RE: PCN # ESU270-82 – SOT23-3L additional backend location approval

<b>PCN# :</b> ESU270-82    Date:    August 15 <sup>th</sup> , 2022  Product Identification : SOT23-3L additional backend location approval Implementation Date for Change: Nov 15 <sup>th</sup> , 2022 or sooner	<b>Contact Information</b> Name: Sophia Hu Title: Assistant Product Manager Phone # : +86 13771377277 Fax# : N/A E-mail : shu@littelfuse.com
<b>Category of Change:</b> <input type="checkbox"/> Assembly Process <input type="checkbox"/> Data Sheet <input type="checkbox"/> Technology <input type="checkbox"/> Discontinuance/Obsolescence <input type="checkbox"/> Equipment <input checked="" type="checkbox"/> Manufacturing Site <input checked="" type="checkbox"/> Raw Material <input type="checkbox"/> Testing <input type="checkbox"/> Fabrication Process <input type="checkbox"/> Other: _____	<b>Description of Change:</b> Approve additional backend assembly, test, and packing location for SOT23-3L. There are no changes to fit, form & function of the finished products.

**Prepared By** : Jordan Hsieh-Product Engineering Manager,  
Raider Chen-Product Engineer, Sophia Hu- Assistant Product Manager  
**Date** : 2022/8/5

**6.1 Reliability summary report:**

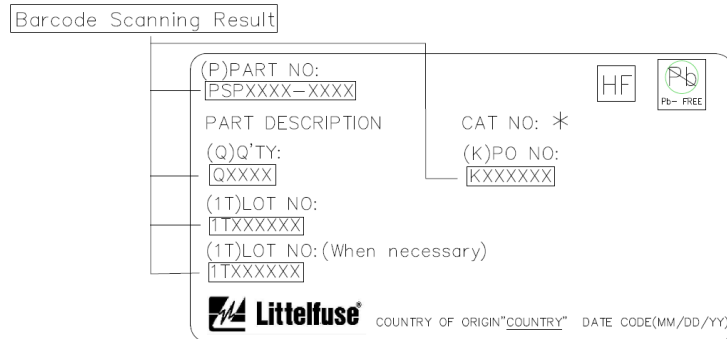
**6.0 Reliability Test Results Summary:**
